Now Available! New 6" DVL Stovetop Adapter for Recessed Stove Collar

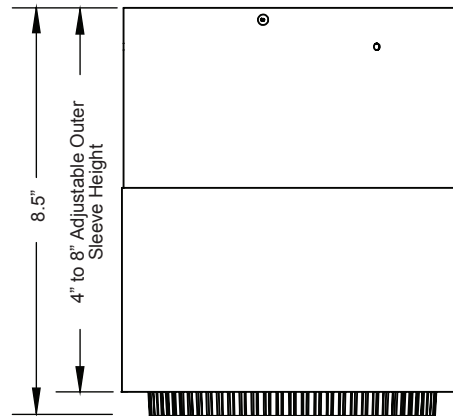
This adapter is similar to our current DVL adapter but has a longer inner sleeve and an additional wrapping outer sleeve.

-Longer inner sleeve enables adapter to be used on short stove collars as well as on stove collars with nearby interfering features, like a convection deck.

-Wrapping outer sleeve conceals coupling between stove and adapter, and enables user to install on stoves with collars up to 4 inches tall.

This new design also allows the installer to screw the stove collar to the adapter which is currently not possible on current adapter. The current adapter relies on friction fit and weight of above stove pipe, but would be much safer if adapter was secured with screw.
